HISTORIC AND DESIGN REVIEW COMMISSION

May 15, 2019

HDRC CASE NO: 2019-262
ADDRESS: 227 DWYER AVE
LEGAL DESCRIPTION: NCB 173 BLK 2 LOT 1 (HERITAGE PLAZA)
ZONING: D
CITY COUNCIL DIST.: 1
APPLICANT: Jim West/GFF
OWNER: Ricky DeCamps/DELTA MAIN & DWYER LLC
TYPE OF WORK: Modification to a previously approved design in regards to windows
APPLICATION RECEIVED: April 29, 2019
60-DAY REVIEW: June 28, 2019
CASE MANAGER: Edward Hall

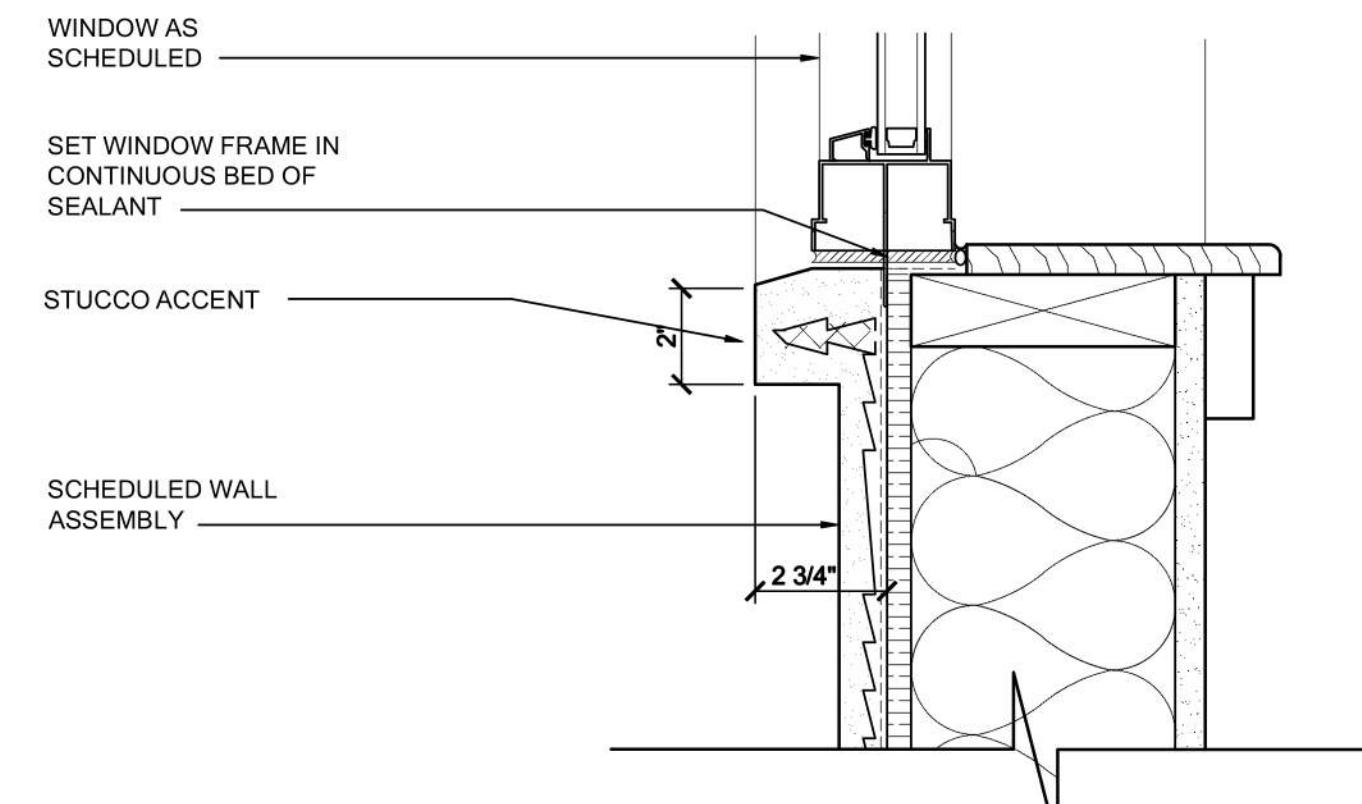
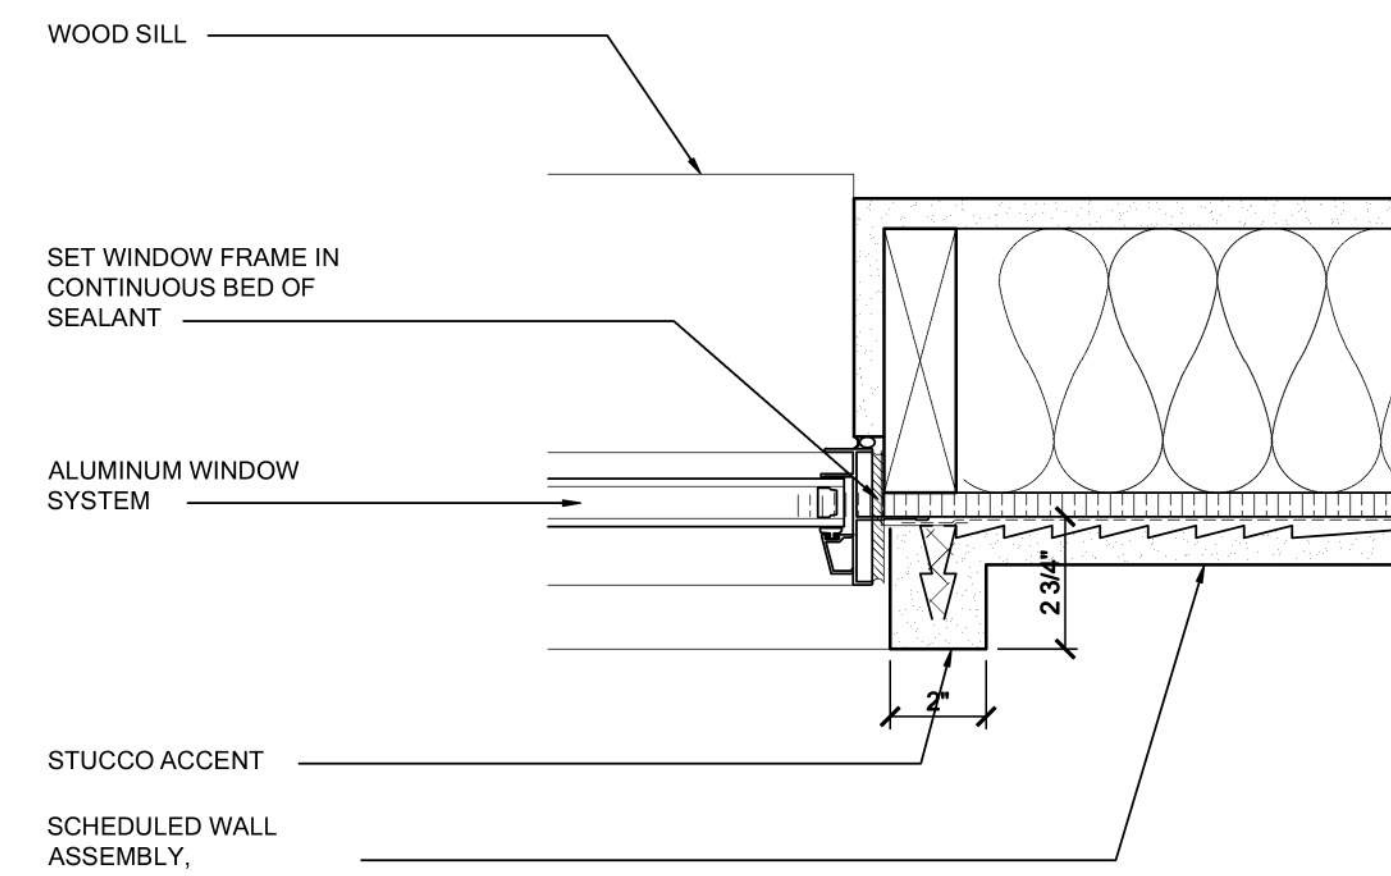
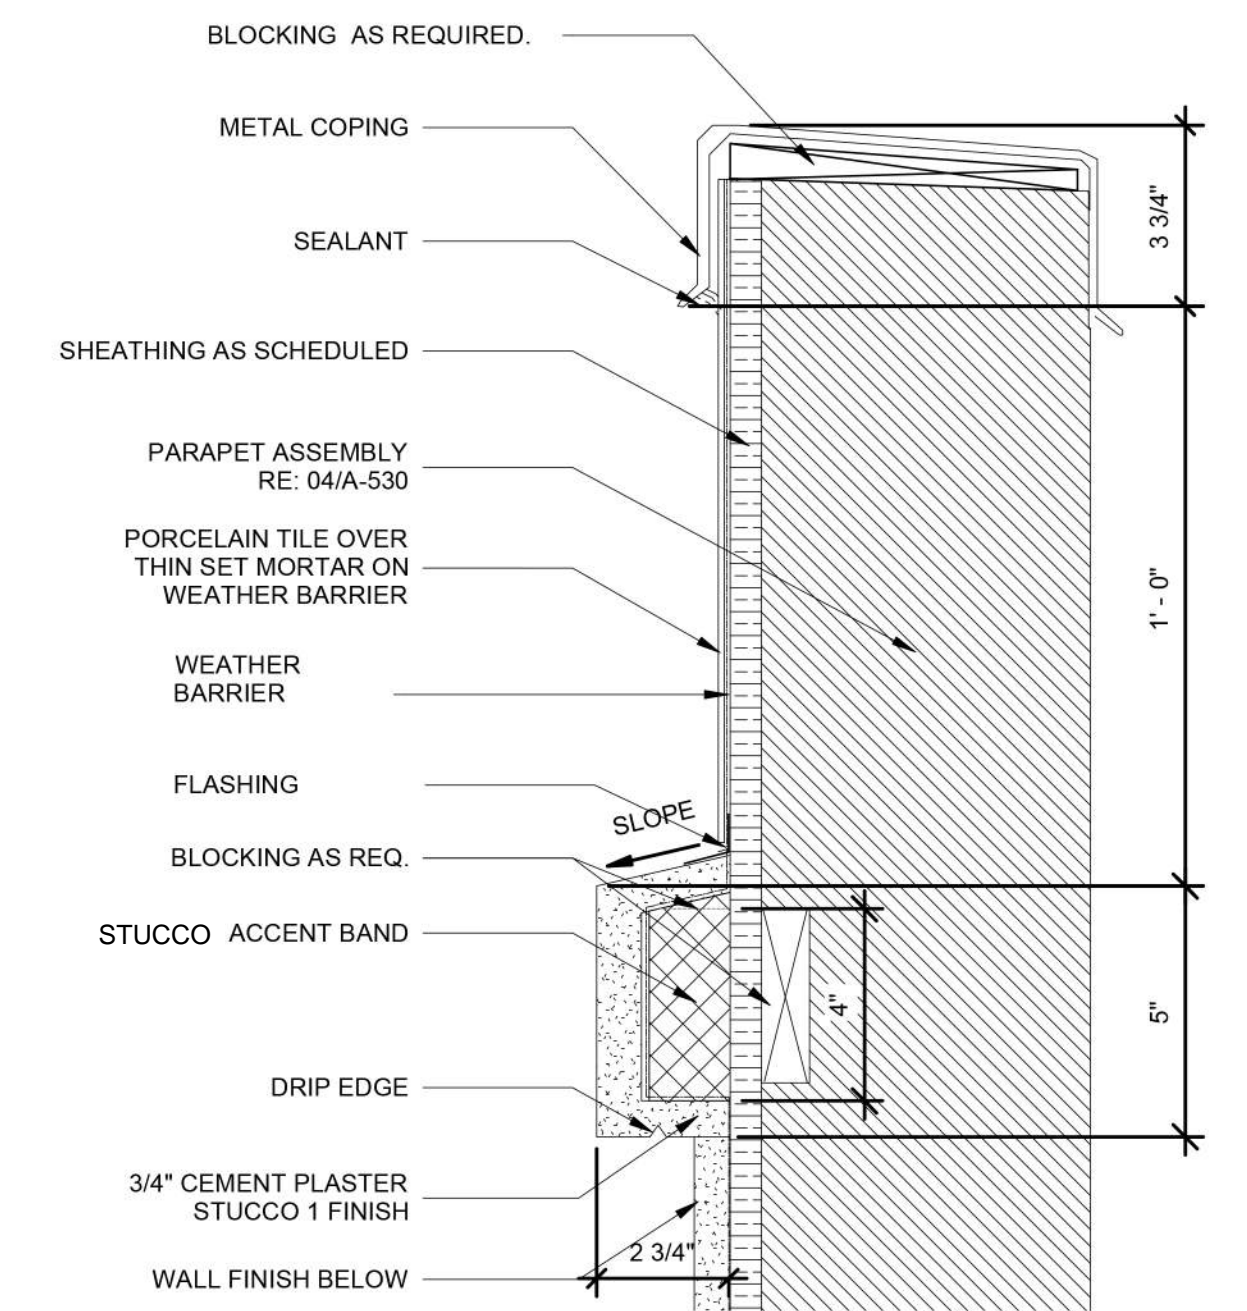
- ii. That window frame color be presented to staff. White windows are not to be used. **The applicant has met this stipulation.**
- b. WINDOW RECESS – The applicant previously noted that all windows would be recessed a minimum of two (2) inches within walls to cast a shadow line and provide façade depths. At this time, the applicant has requested a modification to the recess of windows which includes the installation of stucco accents and trim around each window opening.

1. Staff does not recommend approval of item #1, the elimination of the recess of at least two (2) inches for all exterior windows based on finding b.
2. Staff recommends approval of the proposed façade tile design based on finding c.
